DRAWING UPDATES
02.03.26:

Project Radcliffe Civic Hub

Drg Title Proposed Levels & Drainage

Drg No. RADHUB-PIE-00-00-DR-L-0002 S3
Suitability
Revision C15

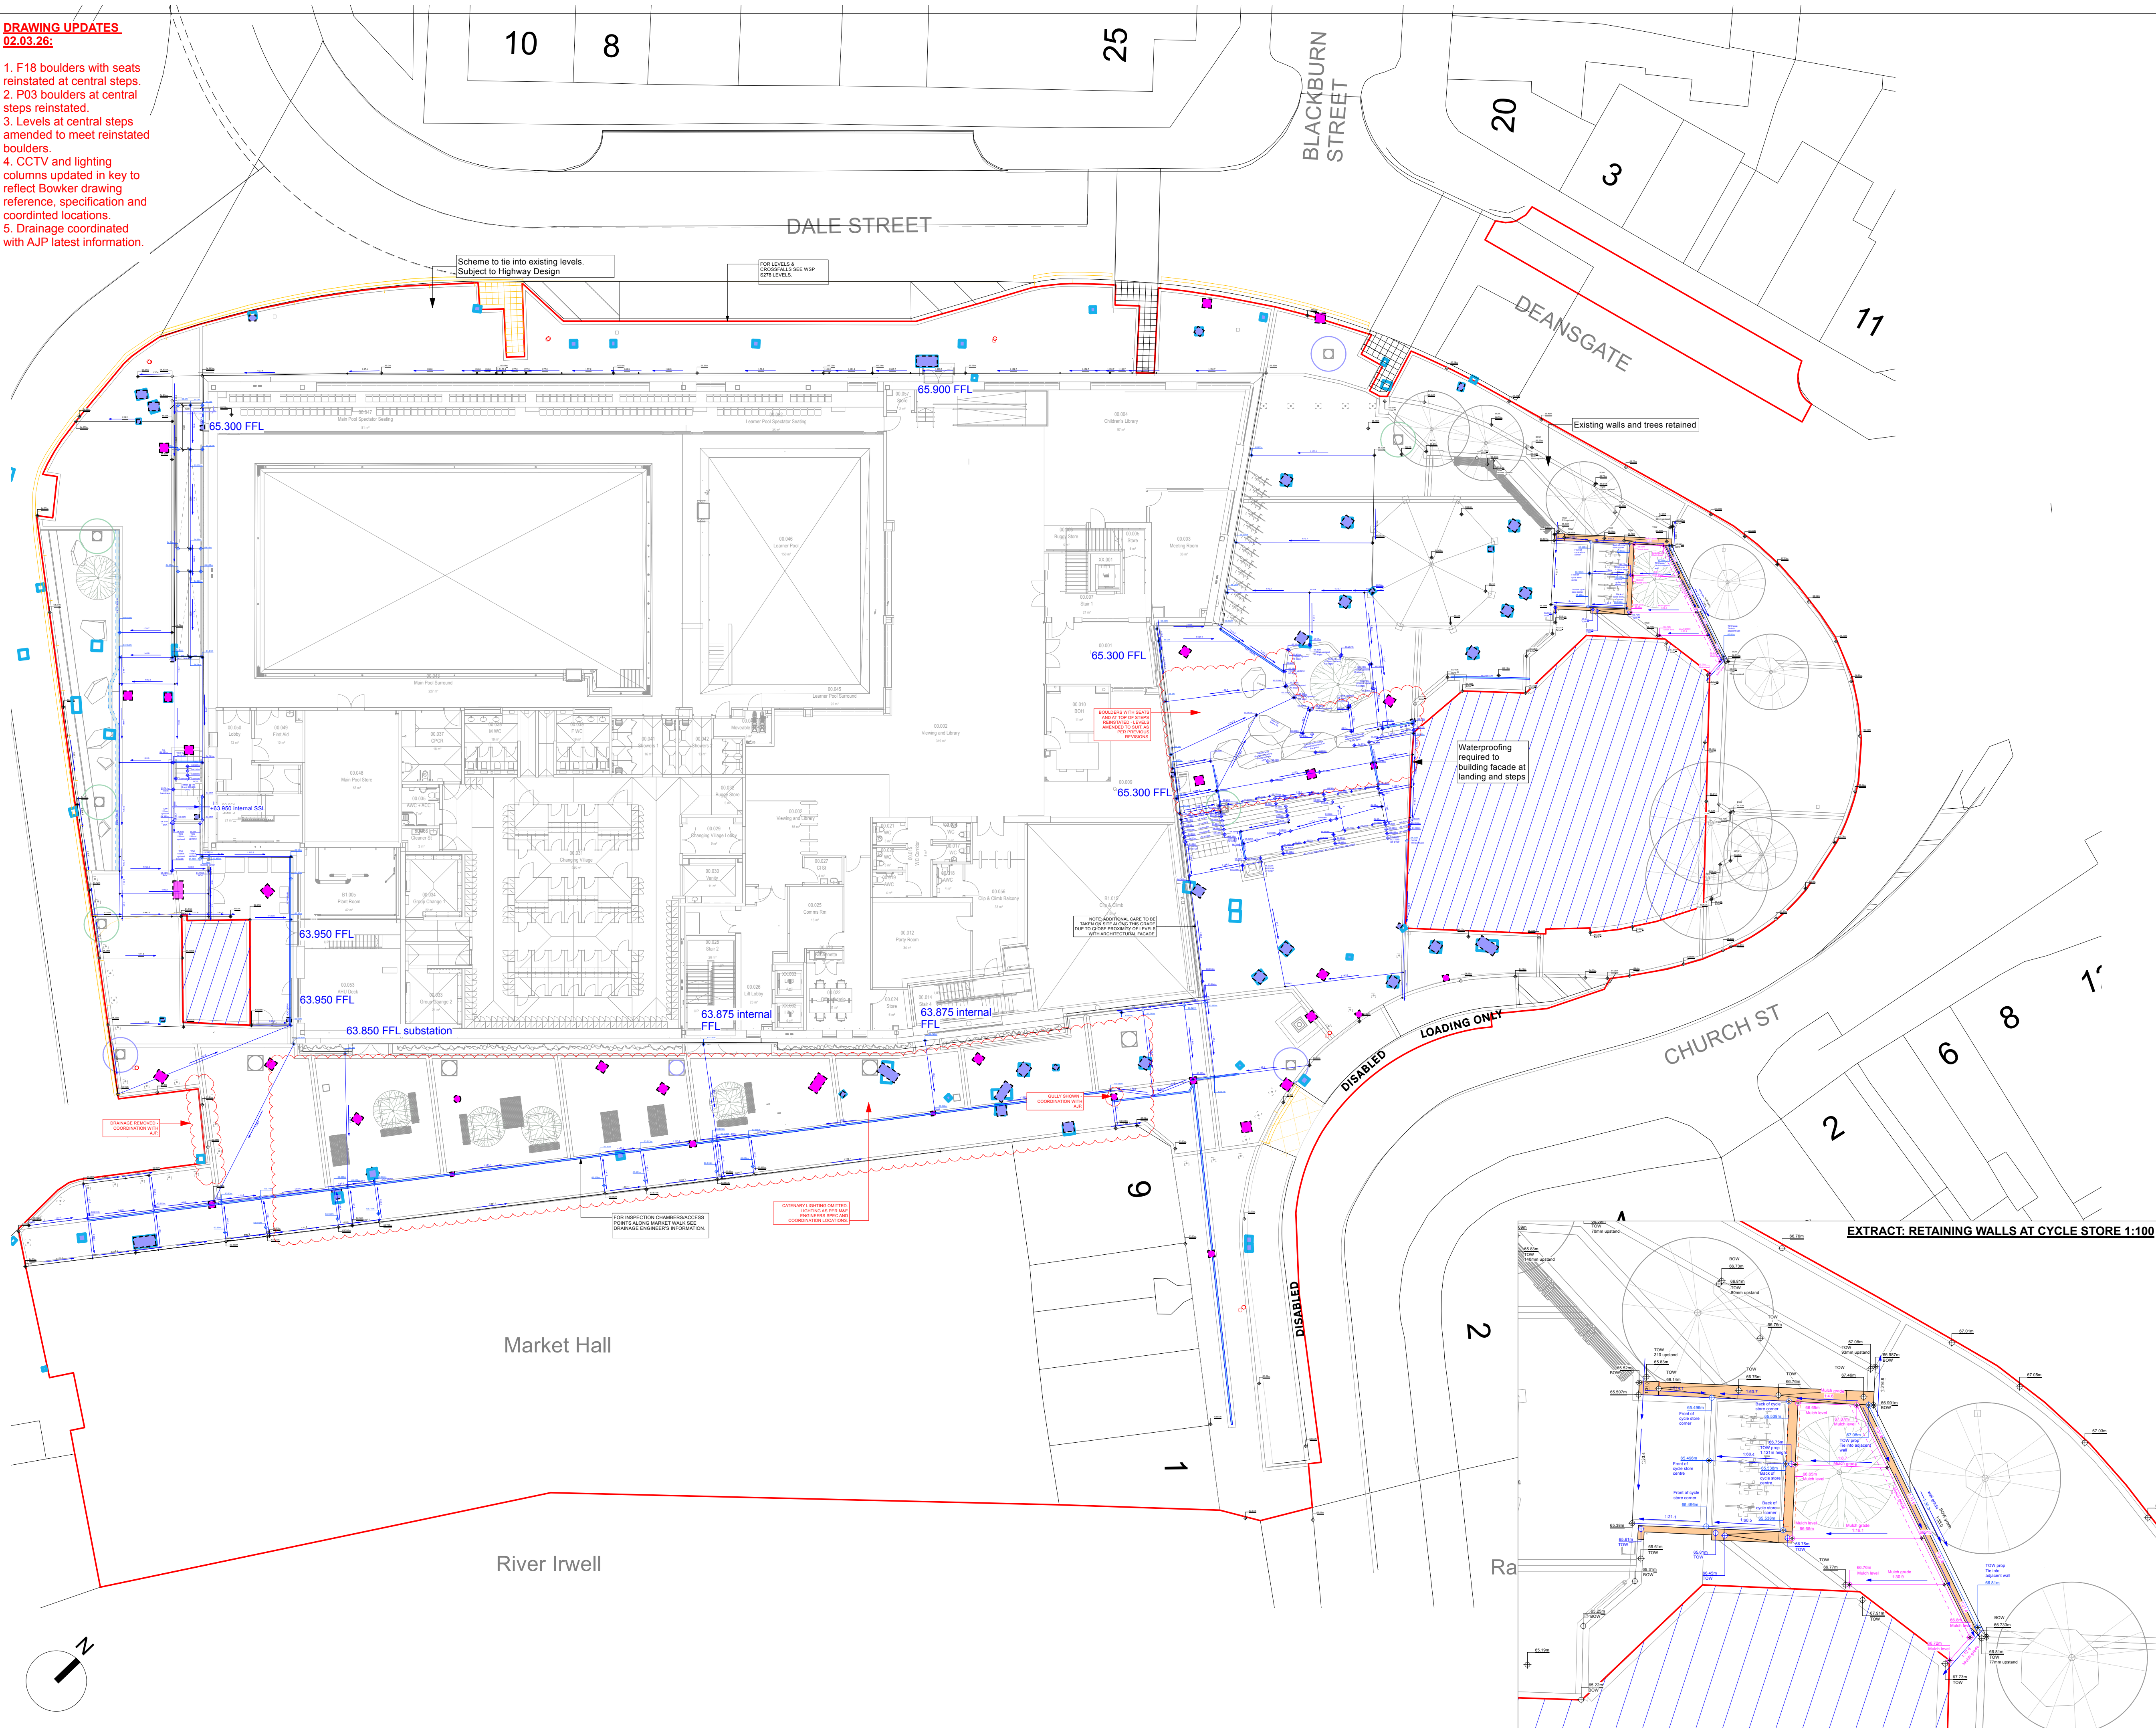
1. F18 boulders with seats reinstated at central steps.
2. P03 boulders at central steps reinstated.
3. Levels at central steps amended to meet reinstated boulders.
4. CCTV and lighting columns updated in key to reflect Bowker drawing reference, specification and coordinated locations.
5. Drainage coordinated with AJP latest information.
